Application No. 10/077,578

<u>REMARKS</u>

This Amendment is responsive to the Office Action mailed on December 16, 2004. Claims 36, 39-53, and 56-70 are now pending in this application. Claims 36, 39, 50, 53, 56, 69 and 70 are amended herein.

Inner section (prior to final fabrication)

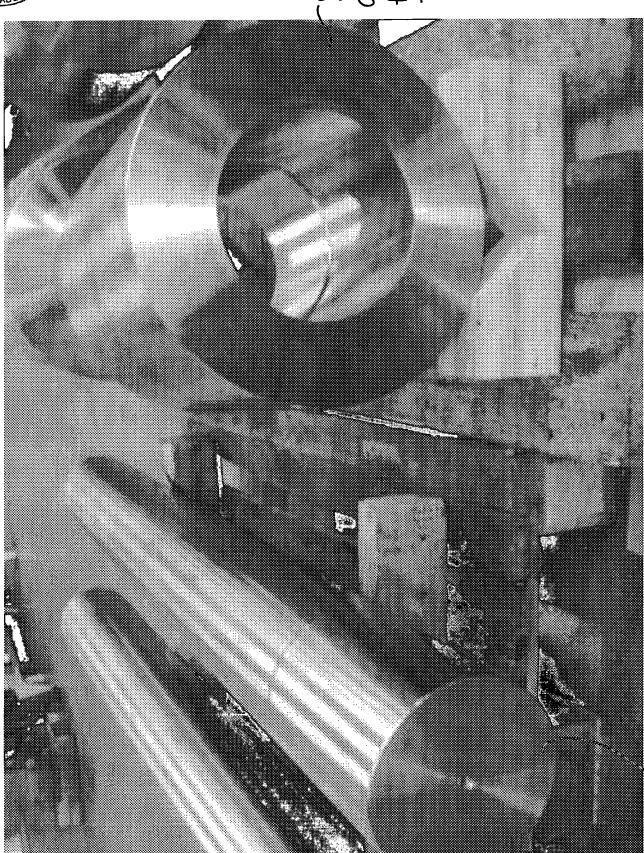
The Examiner has rejected Claims 36, 39-53, and 56-70 stating that the drawings and specification fail to describe any pressure force which will allow tension along the tool. The Examiner states that Figure 4 merely shows a screw 226 being screwed into an element 224, while compressing elements 102 and 230. The Examiner states that from the figures and the drawings it appears there is no tension anywhere, only compression at the local region between the form locking element 224 and the end face 230. The Examiner concludes that there would

have to be a gap between the ring 102 and the inner section 202 and no threads on the interior of the support ring to have any tension along the cutting tool.

The Examiner's rejection is respectfully traversed in view of FIG. 4 and Applicant's Detailed Description. The specification provides an adequate disclosure so that one skilled in the art could provide a device for processing web materials including an outer face that includes at least one end face on which a pressure force is applied to provide tension along the tool. Applicant's disclosure at page 15, lines 10-12 provides that, for example, a form-locking element 224 exerts a tensile force on the inner section 202 in the direction of the outer sleeve 208 parallel to the axis of rotation 84. For purposes of explaining the operation of the invention, Applicant is attaching hereto Exhibits A, B and C. Exhibit A is a photograph of portions of the claimed structure. Exhibit B is a sketch illustrating the tensile force provided in accordance with the invention. Exhibit C is a photograph of the inner section and outer sleeve stock, prior to being machined into their final configurations.

In Exhibit A, it can be seen that by tightening the screws 224 (yellow arrows), a compressive force (red arrows) is provided on the end face of the outer sleeve, which pulls on the inner section (inner core) to provide the claimed tensile force (white arrows)

Applicant's disclosure at page 15, lines 5-9, explains that, for example, a form-locking connection 220 comprises a form-locking element 224 which is formed, for example, by a screw with a screw head 226. The screw head 226 makes a contact surface 228 available, by means of which a pressure force can be exerted on an end face 230 of the outer sleeve 208 in the direction of the inner section 202 parallel to the axis of rotation 84. As disclosed, the pressure force may be exerted by the contact of the screw head 226 via a contact surface 228 on the end face 230. The inner section 202 is free to expand to mate with the end face 249 of the outer sleeve 208 providing a tensile force on the inner section 202. This is demonstrated by the sketch of Exhibit B, which shows how, when screwed into the inner section 202, the screws 224 pull the inner section against the end face of outer sleeve 230 to impart a tensile force on the inner section. As can be seen in Exhibit C, the inner section is fabricated from a solid core, and the outer sleeve is fabricated from thick-walled cylinders into which the inner section is inserted. The inner section

can therefore be stretched along its axis within the outer sleeve. This stretching results from the tensile force depicted in Exhibits A and B.

The amount of movement between the inner section and the end face of the outer sleeve can be extremely small, and those skilled in the art would understand that a gap (which may also be extremely small) is provided between the inner section 202 and the outer sleeve 208 at the respective mating annular surfaces 247 and 249. Indeed, the provision of such a gap is specifically disclosed on page 16, lines 5-8 of Applicant's specification, which explains that the annular surface of the expansion member facing the inner section has clearance in relation to an end face of the inner section, in order not to hinder the expansion thereof when subjected to the tensile stress.
